5.4L INTERMITTENT RATTLE NOISE / ROUGH IDLE WHEN ENGINE IS AT OPERATING TEMPERATURE

TSB 12-7-10

2004-2010 F-150
2005-2010 F-250, F-350
2005-2012 Expedition

Figure 1 - Article 12-7-10

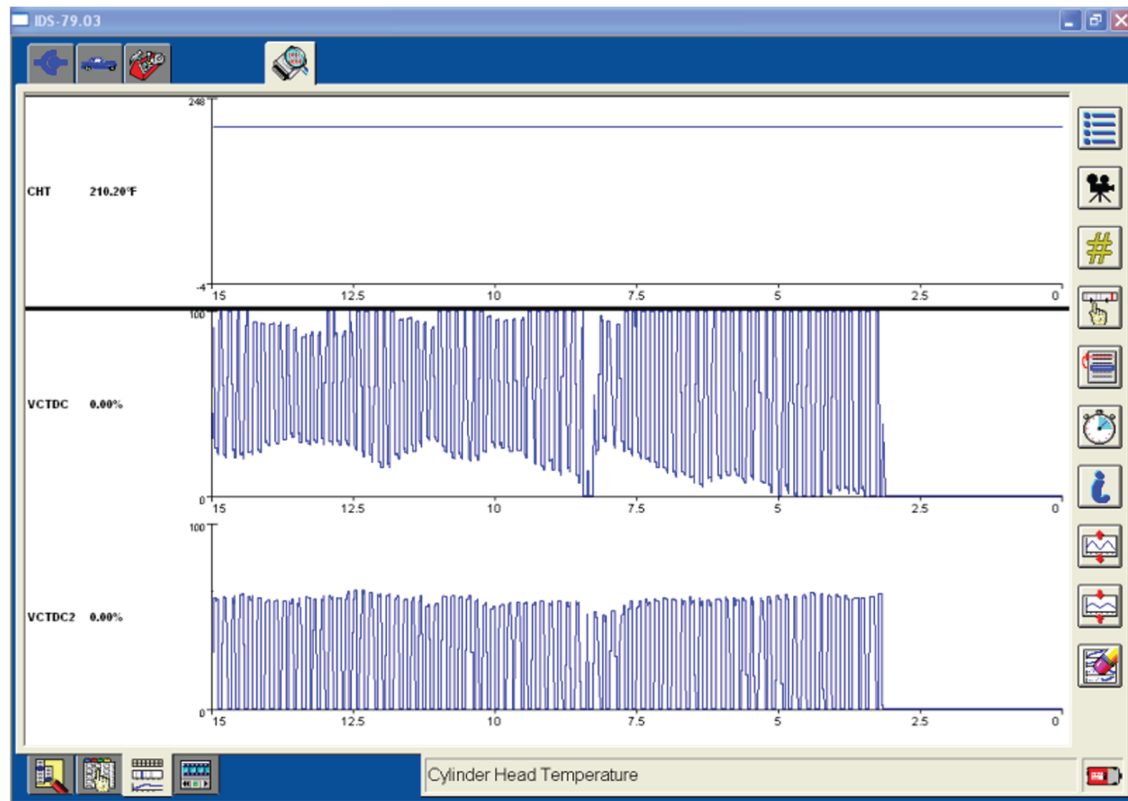
- a. Start IDS
 - b. Select Data Logger
 - c. Select PIDs VCTDC, VCTDC2, and CHT
2. With the engine idling at normal operating temperature CHT above 93 °C (200 °F) apply the parking brake and hold service brake pedal firmly with transmission selector lever in (D). Raise engine RPMs from idle to approximately 1500 RPMs and release the throttle. Does the vehicle exhibit a rattle type noise with a rough idle and are the cam solenoid duty cycle PID values oscillating after RPMs return to idle speed? (Figure 1)

- a. Yes - Proceed to Step 3.
- b. No - This article does not apply. Refer to Workshop Manual (WSM), Section 303-00 for normal diagnostics.
3. Replace both the left and right Variable Camshaft Timing (VCT) Oil Control solenoids. Refer to WSM, Section 303-04B for 2004 vehicles OR 303-14 for 2005-2012 vehicles.
